Access Compliance Report

Public Rights-of-Way

Intersection ID: 10199	Main Street: CALTON_LN	Cross Street: TUCKASEEGEE_RD	Location: E
ADA ID: 5CE6AAF635ED	Ramp Type: Perp	Initial Pass/Fail: Fail	Overall Compliance: No
		Severity Score: 22.5

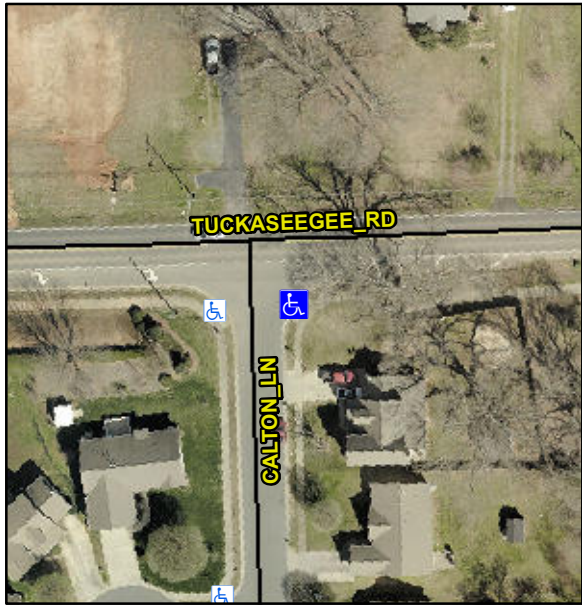
Codes/Mitigation Info/Possible Solution			Field Measurements/Component Compliance					
	Possible Solutions:		Compliance	Description	Data	Compliance	Description	Data
	Remove & Replace Entire Ramp.		N/A	Ramp Length (in)	48.0	No	Ramp Slope (%)	9.3
			No	Ramp Width (in)	45.0	No	Ramp XSlope (%)	2.1
			N/A	Flare Type LT	N/A	N/A	Flare Type RT	N/A
			N/A	Flare Slope LT (%)	N/A	N/A	Flare Slope RT (%)	N/A
			N/A	Flare Traversable LT?	N/A	N/A	Flare Traversable RT?	N/A
			N/A	Landing Length (in)	N/A	N/A	DWS Provided?	N/A
			N/A	Landing Width (in)	N/A	N/A	DWS Contrast?	N/A
			N/A	Landing Slope (%)	N/A	N/A	DWS Length (in)	N/A
			N/A	Landing X Slope (%)	N/A	N/A	DWS Full Width?	N/A
Surveyor Notes:		N/A	N/A	Landing Curb? (Y/N)	N/A	N/A	DWS Offset (in)	N/A
PROW/ADA:		Not Found, R304.5.1, R304.2.2, R304.5.3	N/A	Shared Landing?	N/A	N/A	Gutter Slope (%)	N/A
			N/A	Gutter Ponding?	N/A	N/A	Gutter X Slope (%)	N/A
			N/A	Gutter Lip Ht (in)	0.5	N/A	Painted X Walk2?	N/A

N/A	Painted X Walk1?	No	N/A	X Walk 2 Direction	N/A
				X Walk 1 Direction	To W		X Walk 2 Width (in)	N/A
			N/A	X Walk 1 Width (in)	N/A	N/A	X Walk 2 Slope (%)	N/A
				X Walk 1 Slope (%)	3.0		X Walk 2 X Slope (%)	N/A
				X Walk 1 X Slope (%)	1.6		Ramp inside XWalk2?	N/A
			N/A	Ramp inside XWalk1?	N/A	N/A	Clear Space?	N/A
				Road Slope (%)	N/A	N/A	Clear Space to XWalk (in)	N/A
				Road X Slope (%)	N/A	N/A	Storm Grate/Utility Hazard?	N/A
			N/A	Any Obstructions?	N/A	N/A	Storm Grate/Utility Type	
				Obstruction Type				
					N/A			N/A
						Yes	Surface Condition? (G/P)	Good
Street 1 Name		CALTON LN						
Stop Condition-Street 2		StopSign						
Street 2 Name		N/A						
Stop Condition-Street 1		N/A						
Total Cost:		\$ 1850.00
